DDEC® VI Troubleshooting

NUMBER: 08 DDEC VI-45 S.M. REF.: 88 ENGINE: DD15 DATE: September 2008

SUBJECT: NEW SPN 157

PUBLICATION: DDC-SVC-MAN-0029

d150007a

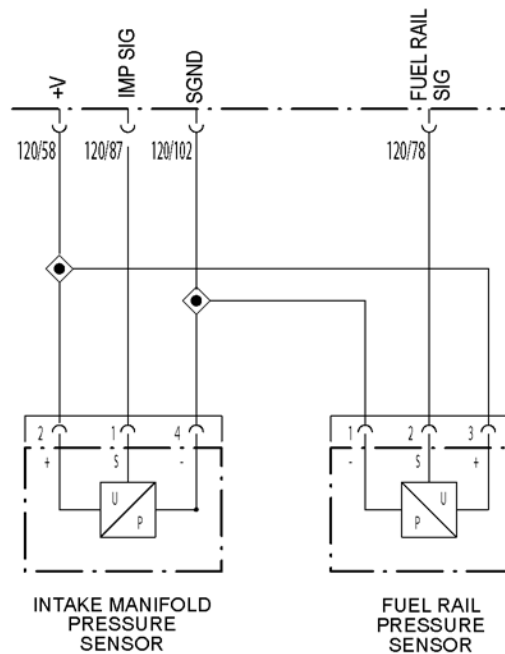
SPN 157 has been added to the manual.

This SPN indicates there is a problem with the Fuel Rail Pressure Sensor signal.

This diagnostic condition is typically an erratic Fuel Rail Pressure Sensor signal.

Step 7 of this procedure (PLV counter) must be verified.

1. Disconnect the Fuel Rail Pressure Sensor.
2. Inspect the Fuel Rail Pressure Sensor harness connector for loose, bent, spread or corroded pins.
 - [a] If pin damage is found, repair as necessary. Verify repairs.

- [b] If no connector damage is found, go to the next step.
3. Disconnect the MCM 120-pin connector.
4. Inspect pins 58, 78, and 102 for bent, spread or corroded pins.

- [a] If pin damage is found, repair as necessary. Verify repairs.
 - [b] If no connector damage is found, go to the next step.
5. Connect DDDL 7.X.
6. Turn the ignition ON (key ON, engine OFF).

7. Under the Actions” drop down menu, select “PLV Change.” On the PLV Change screen select “Read Accumulator.”
 - [a] If the PLV counter is greater than 50, the PLV must be replaced. After PLV replacement, reset the PLV accumulator value via the “Reset Accumulator” button.

- [b] If the PLV counter is less than 50, troubleshooting is complete.
